7900 Wisconsin Avenue, Site Plan 820130170

Description

Summary

Original proposed location of new Wisconsin Avenue fire hydrant

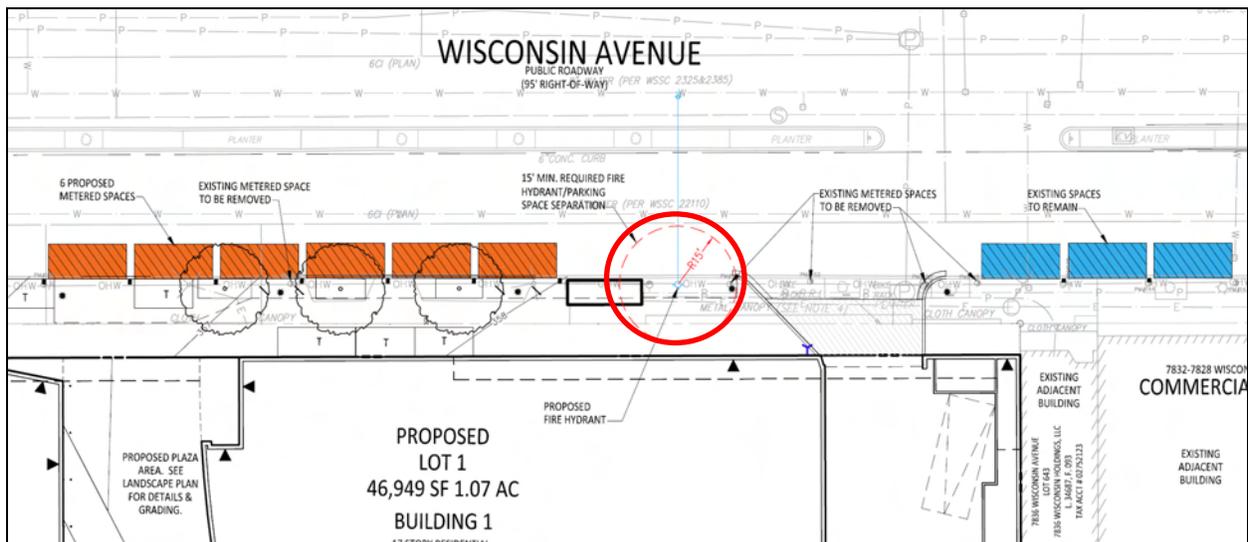
Staff received an e-mail from the owner of the adjacent business on Wisconsin Avenue, Next Day Sign Express (see Appendix B). The owner requested the Applicant to relocate the proposed fire hydrant on Wisconsin Avenue from the south side of the vehicular service drive to the north side, to minimize the potential loss of on-street parking spaces in front of his business. In coordination with staff, the Applicant has agreed to relocate the fire hydrant. Staff has included a condition to that effect.

Proposed relocation of new Wisconsin Avenue fire hydrant
